**ON-SITE SEWAGE DISPOSAL SYSTEM
 HOWARD COUNTY HEALTH DEPARTMENT
 BUREAU OF ENVIRONMENTAL HEALTH**

SUBDIVISION: Blueberry Hill LOT NUMBER: 1

ADDRESS: 2660 Daisy Road PROPERTY OWNER: Hamilton Reed Gagnon 1600 ⁴¹⁰⁻⁴⁴²⁻

SITE DEVELOPMENT PLAN,
 SEDIMENT, EROSION CONTROL PLAN, NOTES & DETAILS
 MINOR SUBMISSION
BLUEBERRY HILL
 LOTS 1, 2 & 3

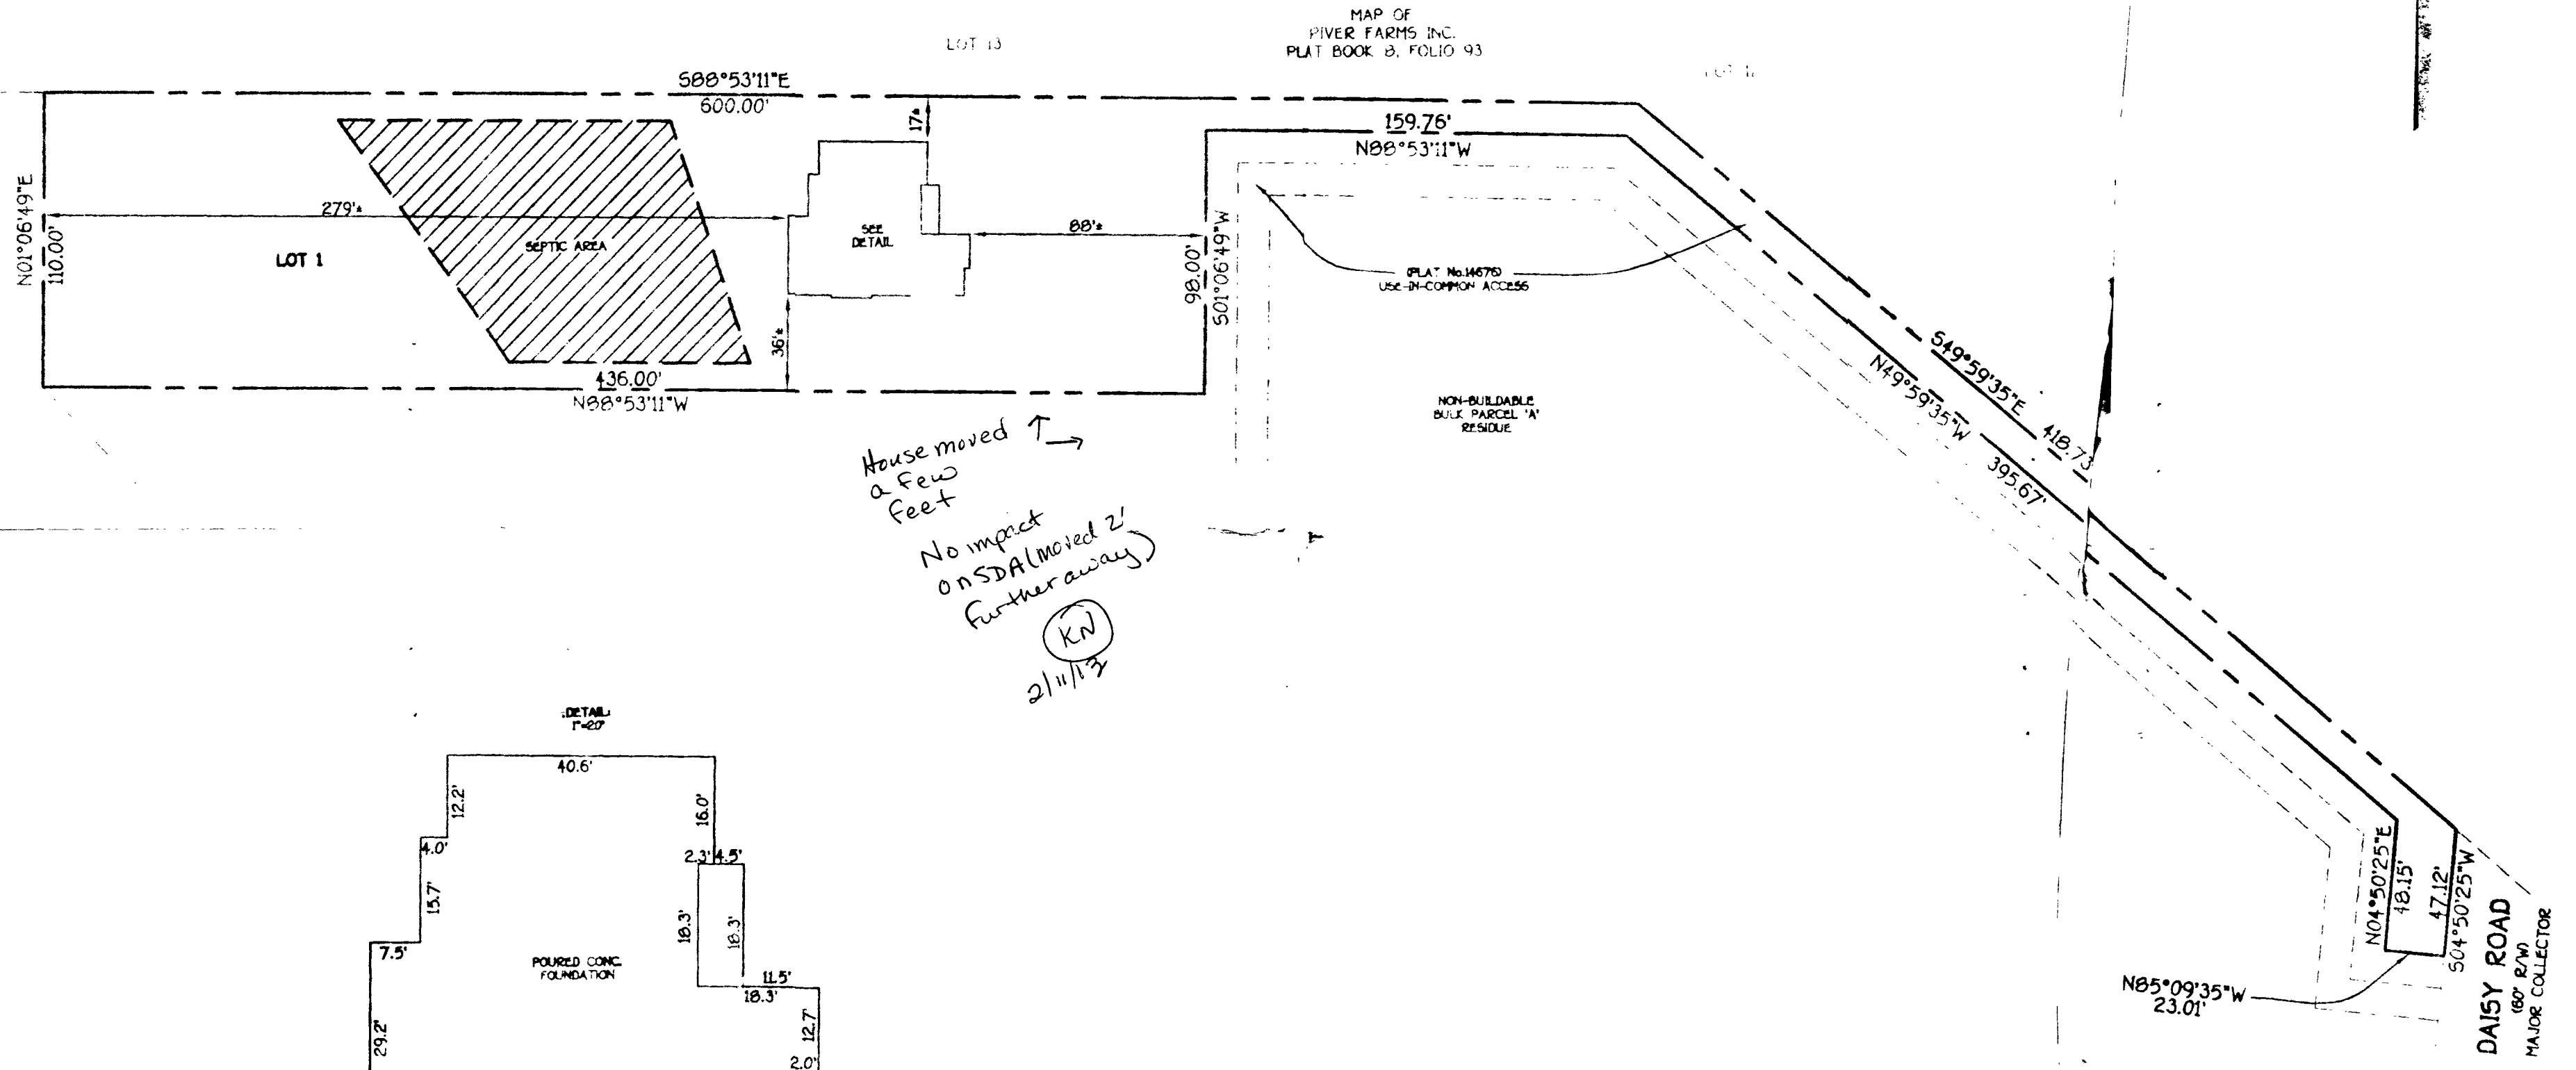
PRE-CONSTRUCTION 3/11/03 Lot stake, horse corr changed, no affect. Install (4) 70' trenches on contour at top of SRA. Call to Jason, changed

INSTALLATION specs to D.B in middle, install (4) 60's. (50)

3/14/03 OK to cover all work, Pump & Alcohol tests needed. (50) 4/4/03 Pump test ok & alarm (KN)

HOUSE LOCATION DRAWING

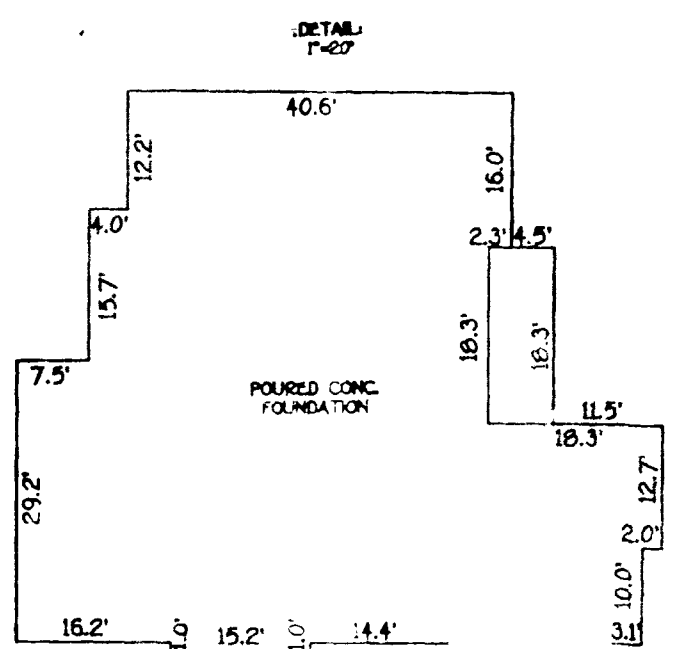
House moved ↑
a few feet
No impact on SDA (moved 2' further away)
KN
2/11/13

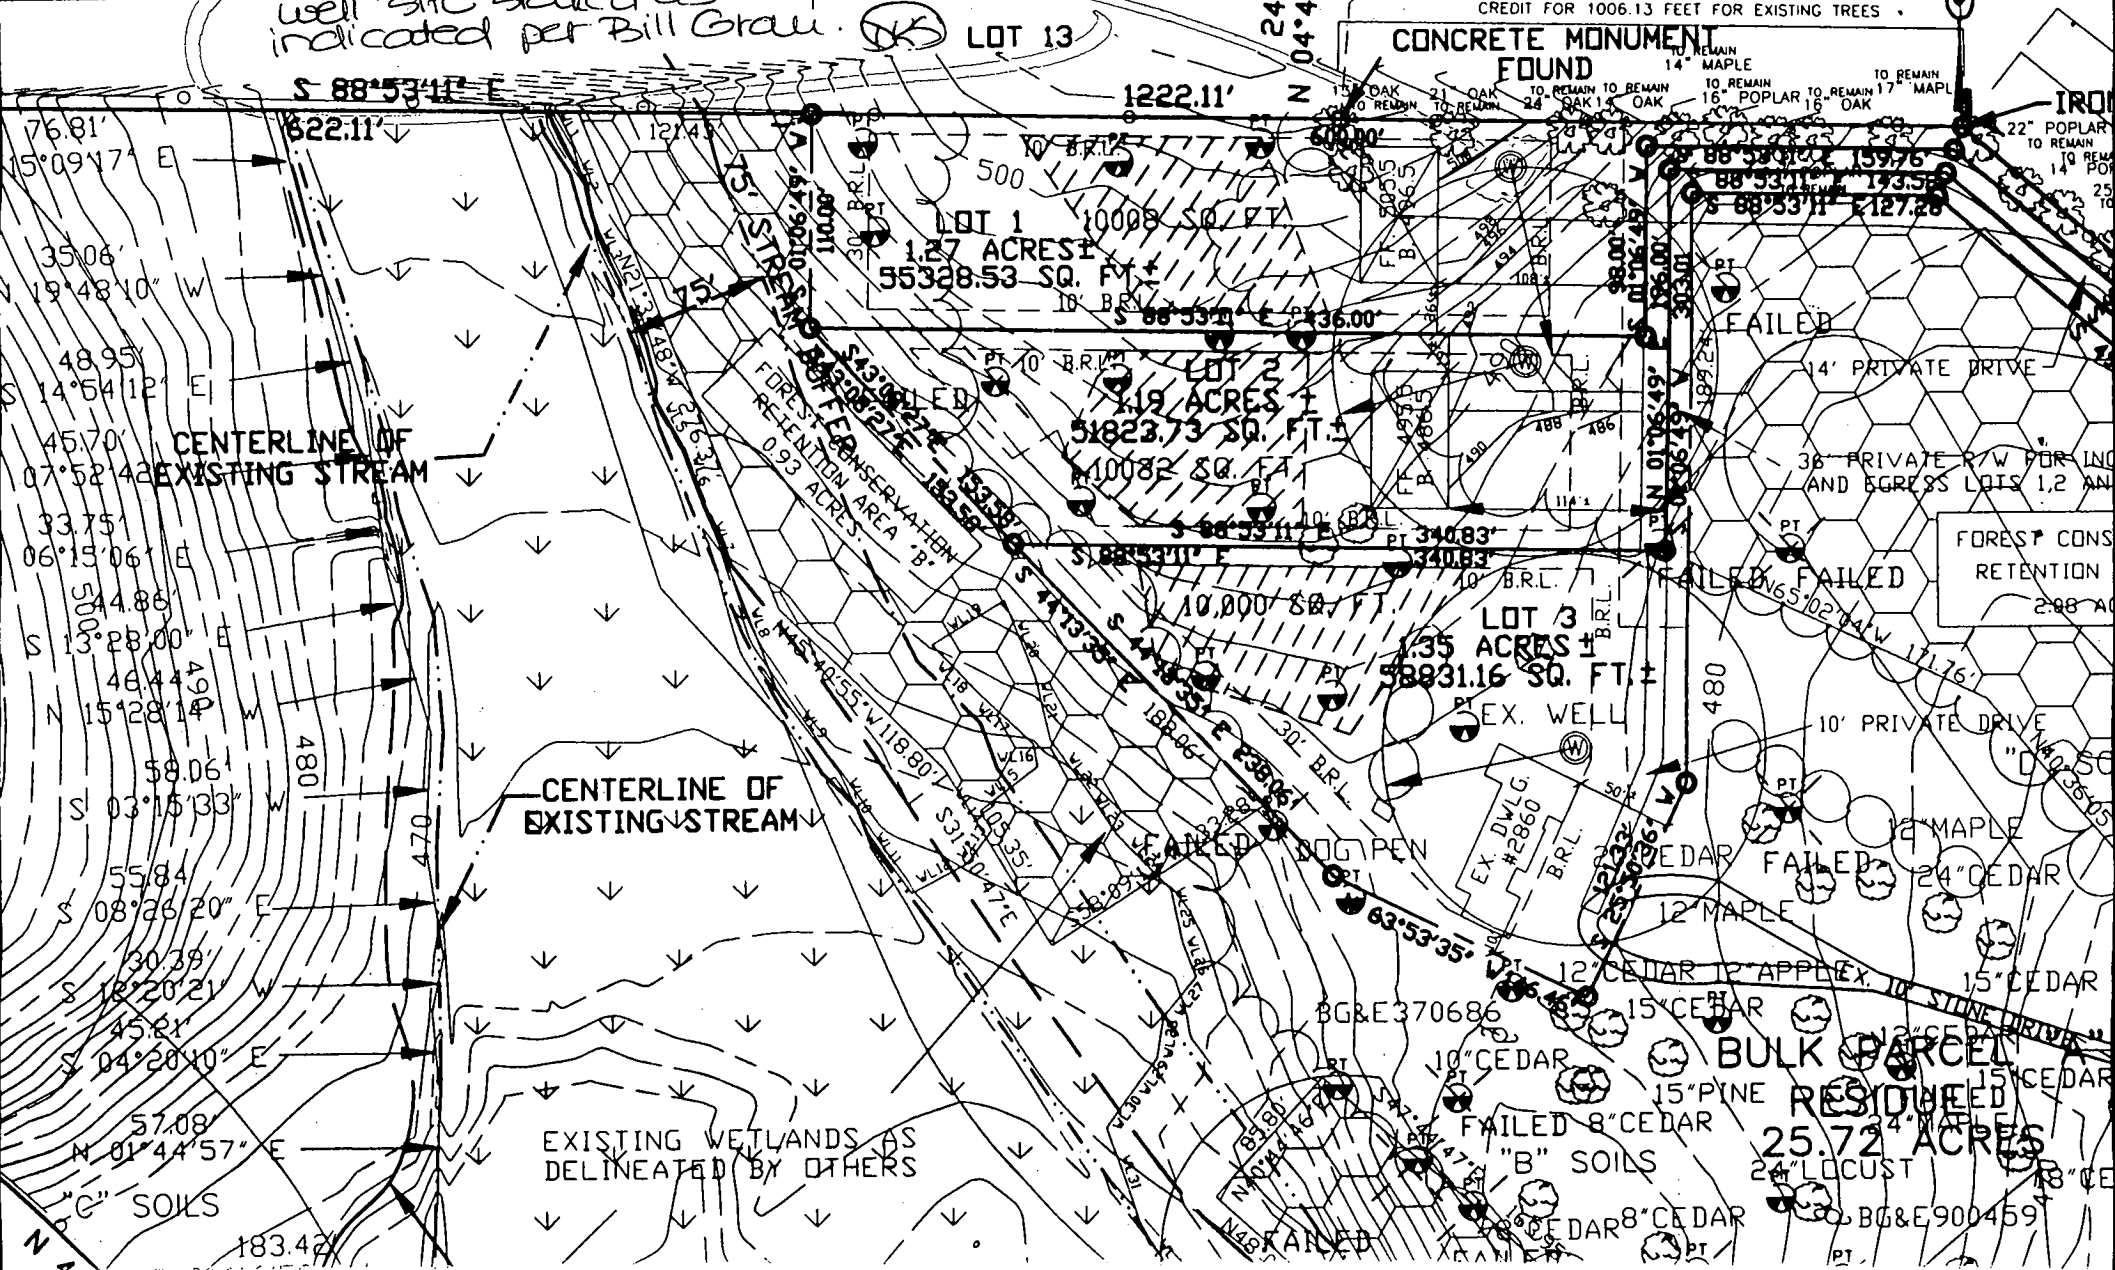
Well site staked as indicated per Bill Grau.
